AMBERLEIGH SHORES

NEW HANOVER COUNTY, NC

LAST REVISED - 12/05/12 (REV 14)

FLOURNOY DEVELOPMENT COMPANY
NEW HANOVER COUNTY, NC
AMBERLEIGH SHORES
PLAN REVISION SUMMARY

C3.5

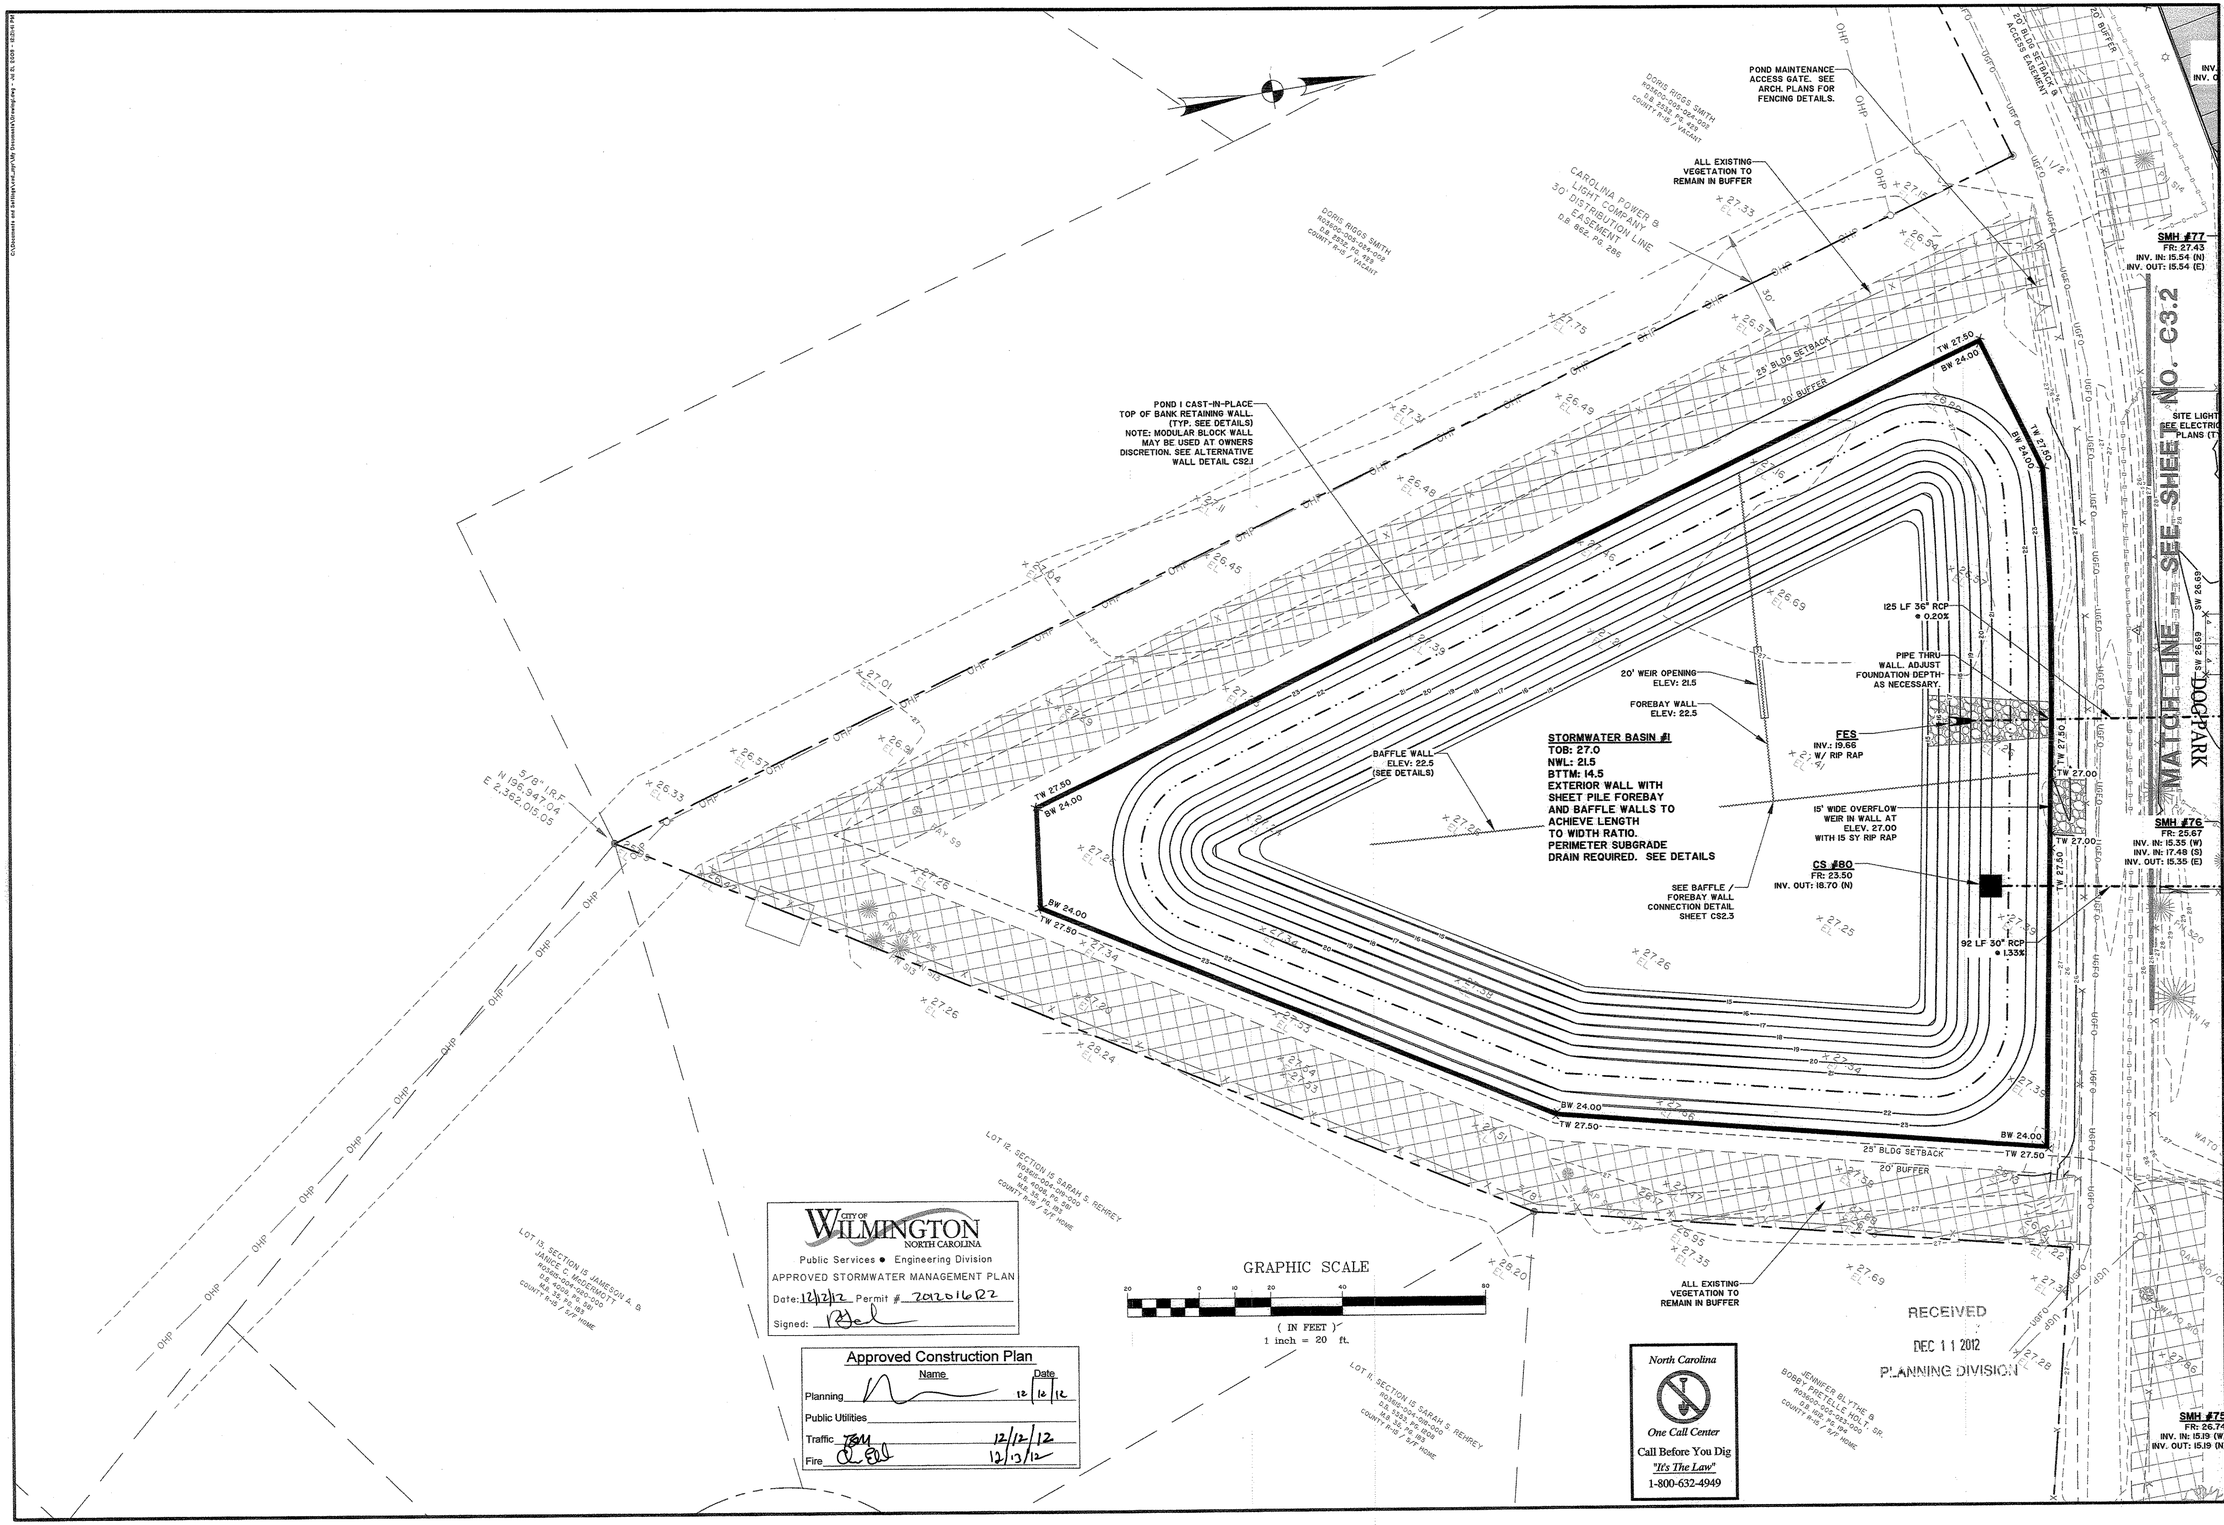
Sheet No.	Revision Comment
G1.3	Update Building Coverage and Impervious Summary Notes.
C2.3	Add note #2 to Sand and Oil/Water Separator Detail.
C3.2	Add Public Drainage Easement for the 29" x 45" elliptical storm drain pipe. Revise location of SMH #78.
C3.5	Add Public Drainage Easement for the 29" x 45" elliptical storm drain pipe.

NO.	DATE	BY	REVISIONS
14	12/05/12	BDR	REV. OUTLET PIPE FROM SMH#74 TO 36" CIRC./ADD FES
12	08/27/12	BDR	ADD PREVIOUS REVISION NOTES
5	04/23/12	BDR	ADD DRAINAGE EASEMENT TO ELLIPTICAL PIPE
4	04/23/12	BDR	SEE REVISION SUMMARY ON SHEET G1.0
1	01/25/12	BDR	SEE REVISION SUMMARY ON SHEET G1.0
